# County of Santa Clara

FILE NUMBER: PLN23-100  
SUBJECT: Major Reclamation Plan Amendment  
SITE LOCATION: 24001 Stevens Creek Blvd.  
DATE RECEIVED: June 14, 2023

The purpose of this letter is to inform you that the Major Reclamation Plan Amendment (RPA) application (“Application”) submitted by Lehigh Southwest Cement Company (“Lehigh”) on June 14, 2023, has been deemed **incomplete**. To complete the Application, Lehigh shall submit the following information requested in Section II (Summary of Required Supplemental Information) no later than 180 days from the date of this letter.

Subject: Preliminary Review Comments of the Geologic and Geotechnical Portions of the Reclamation Plan Amendment, Permanente Quarry, CA Mine ID 91-43-0004, Santa Clara County, California, dated June 2023

#### **Geologic and Borehole Location Map (Copy Provided Below)**

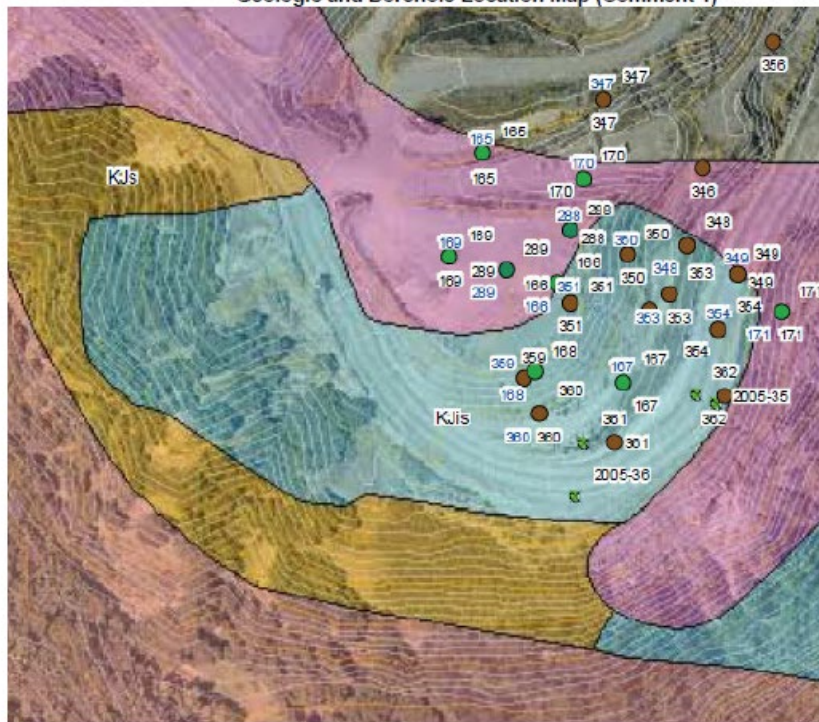
The figure includes the following errors and omissions:

1. The word Quaternary is misspelled twice.
2. The map is missing a north arrow.
3. The map is missing a scale.
4. The geologic map units, except for KJs and KJis, are missing from the map.
5. Map unit KJis is listed as limestone – limestone is typically designated as “ls” or “l”.
6. The geologic contacts are missing from the legend.
7. The geologic units are listed from oldest to youngest – the most common convention is to list them from youngest to oldest.

8. The Santa Clara Formation (QTsc) is of Pleistocene and Pliocene age, designated as QT – Quaternary/Tertiary, not just “QUARNTERNARY”.
9. The legend does not identify the type of borings based on their color.
10. Many borings are shown with duplicates or triplicates of the same number without explanation.
11. There are no elevations shown on the underlying topographic contours.
12. There are no geologic cross sections shown on the map.
